THOMAS & JANETTA AUTREY FAMILY DIVISION **SUBDIVISION**

APPLICATION NUMBER 5 DATE October 16, 2008
APPLICANT Thomas & Janetta Autrey Family Division Subdivision
REQUEST Subdivision

Revised for the October 16th meeting:

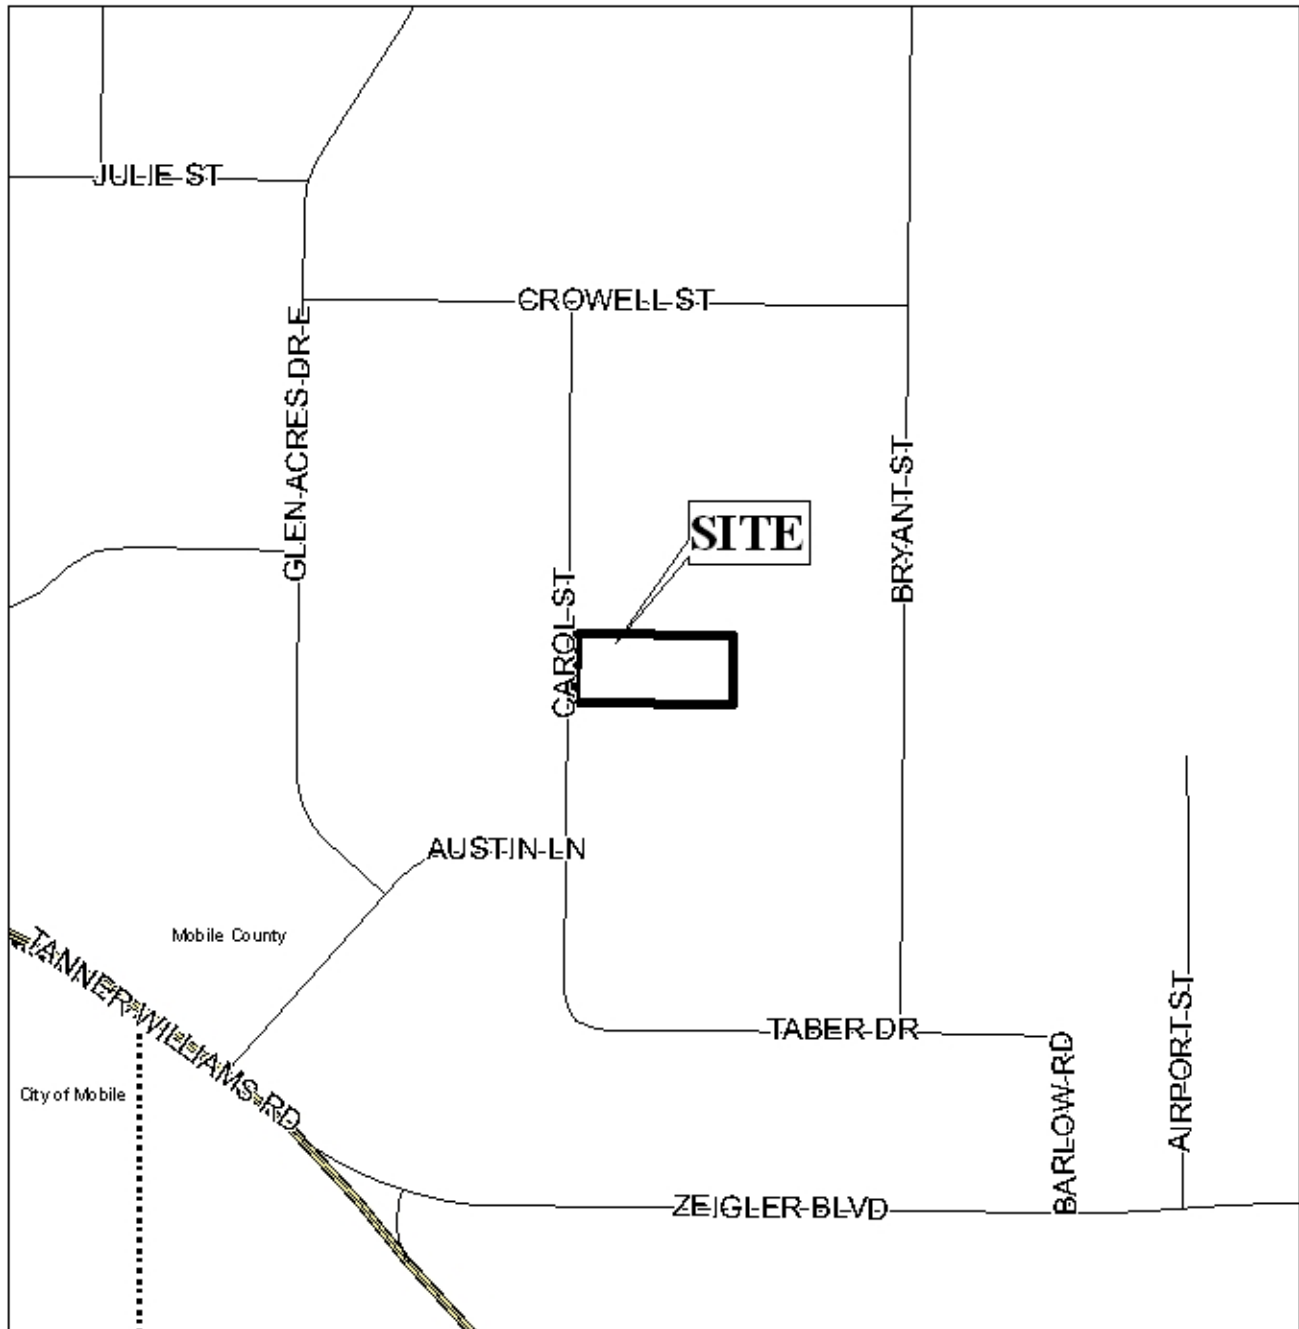
The application was heldover from the September 18th meeting to allow the applicant to revise the plat to show the current structures on the property with all the setbacks depicted and to provide justification for the panhandle lot. The applicant did submit a plat showing the required revisions but did not submit justification for the flag lot. However, the letter submitted by the owner of the property, Thomas Autry, meets the Subdivision Regulation requirements for Family Subdivision section V.D.1, that would allow the flag lot.

All structures located on proposed Lots 1 and 2 meet the required 25' minimum building setback.

- 4) revision of the plat to show the 25' minimum building setback line 25' from where the "pole" portion of the lot intersects with the "flag" portion;

With a waiver of sections V.D.1 and V.D.3 of the Subdivision Regulations, this application is recommended for Tentative Approval subject to the following conditions:

- 1) Placement of a note on the final plat stating that Lots 1 and 2 are limited to one curb cut each onto Carol Street with the size, location and design to be approved by County Engineering;

- 2) Placement of a note stating that no additional subdivision of Lot 2 will be allowed until additional frontage on a public street is provided;
- 3) placement of a note on the plat stating that the development will be designed to comply with the storm water detention and drainage facility requirements of the City of Mobile storm water and flood control ordinances, and requiring submission of certification from a licensed engineer certifying that the design complies with the storm water detention and drainage facility requirements of the City of Mobile storm water and flood control ordinances prior to the issuance of any permits. Certification is to be submitted to the Planning Section of Urban Development and County Engineering;
